<b>Item No.</b> 6.4	<b>Classification:</b> Open	<b>Date:</b> 13 March 2024	<b>Meeting Name:</b> Planning Committee (smaller applications)
<b>Report title:</b>	<b>Development Management planning application:</b> Application 23/AP/2875 for: Full Planning Application  <b>Address:</b> Nunhead Cemetery, Linden Grove, London, Southwark, SE15  <b>Proposal:</b> Demolition of existing Friends of Nunhead Cemetery cabin and construction of a new single storey replacement cabin.		
<b>Ward(s) or groups affected:</b>	Nunhead & Queen's Road		
<b>From:</b>	Director of Planning and Growth		
<b>Application Start Date</b>	24.10.2023	<b>PPA Expiry Date</b>	27.03.2024
<b>Earliest Decision Date</b>	13.03.2024

2. It is proposed to demolish the existing Friends of Nunhead Cemetery cabin and to construct a replacement cabin in the same location.
3. The application is for decision by the planning committee (smaller applications) as the application site lies within Metropolitan Open Land (MOL).

### Proposed front elevations

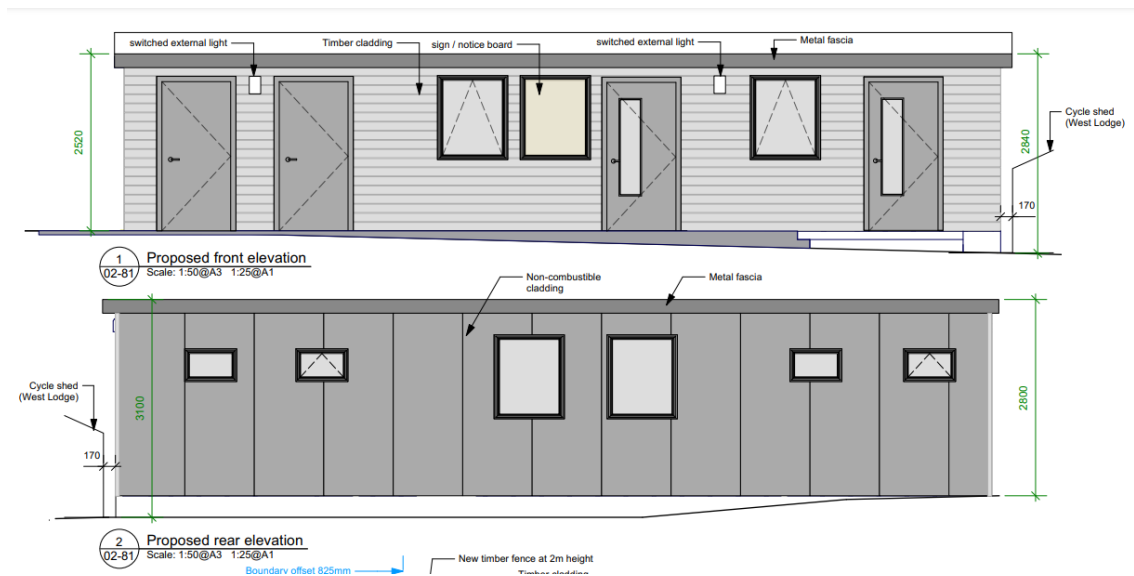
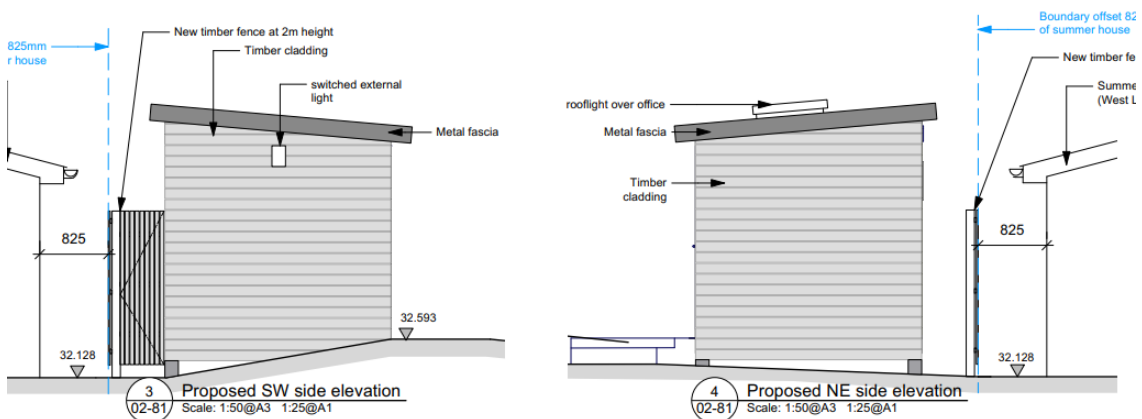
17. The proposals were amended in response to comments from neighbours during the initial public consultation. The changes included:
  - Clarifications to the measurements on the plans (distance between proposed fence and summer house of the West Lodge revised from 800mm to 825mm, distance between bike shed and proposed cabin marked up as 170mm, height of fence revised from 3m to 2m)

- External materials were revised to show timber cladding on both flank elevations to match the front elevation
  - Reduction in height of proposed fence to 2m.

## Proposed plan

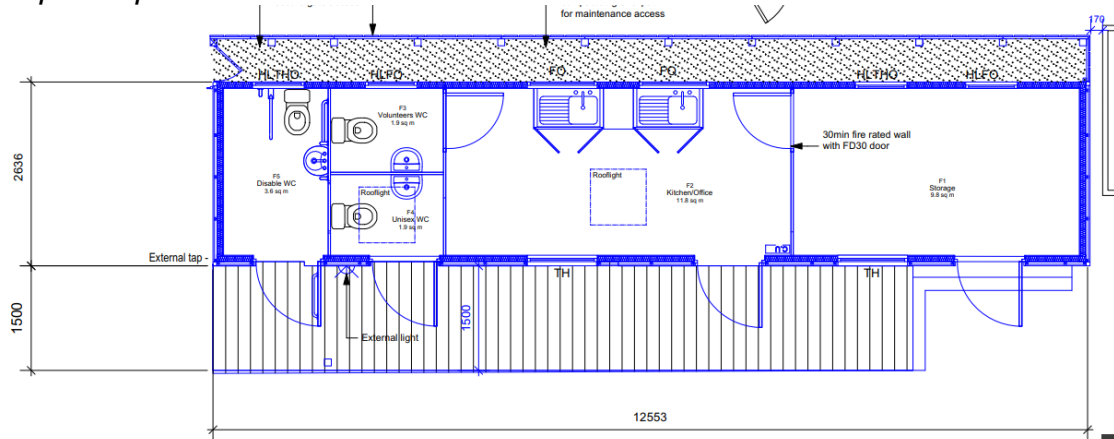
18. The case officer also requested a more detailed proposed block plan better display the position of the replacement cabin relative to the surrounding existing features such as the existing drainage on the cemetery pathway, and for the measurements of the proposed cabin to be fully marked up on the plans.
